DATE: December 1995

GAME: Johnny Mnemonic

SUBJECT: Fuses 104 and/or 105 blowing

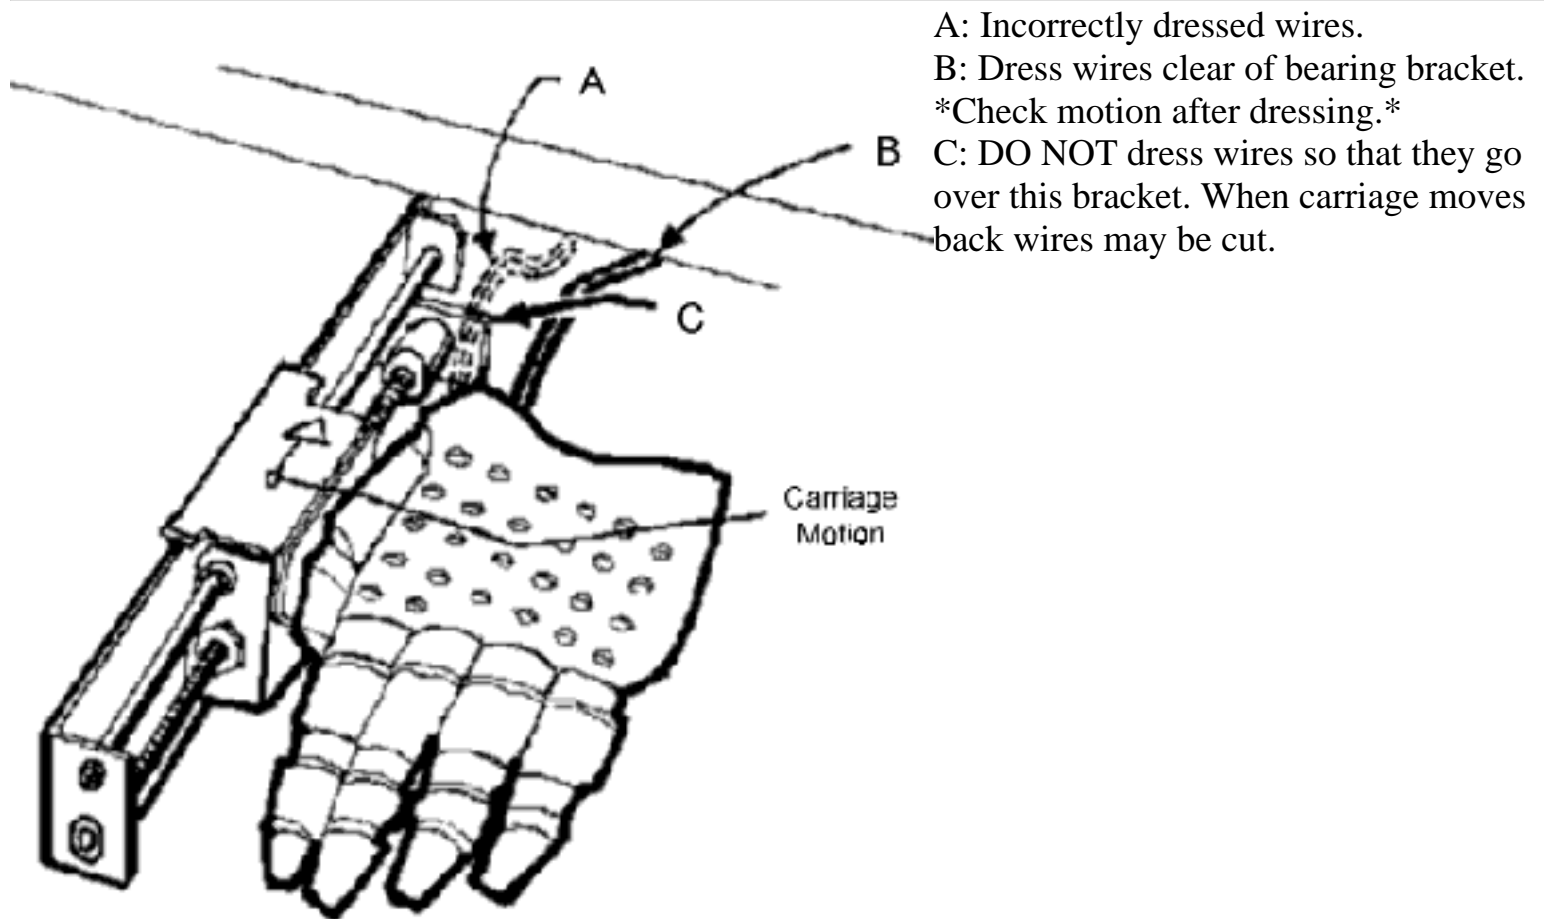
CAUSE: Wires to data glove not correctly dressed.

This service bulletin addresses the problem of fuse 104 and/or fuse 105 blowing on some **Johnny Mnemonic** pinballs. This is caused by the wire harness not being correctly dressed, and thus the wires snag and short to the metal frame.

See diagram below for instructions on correctly dressing the wires to the data glove.
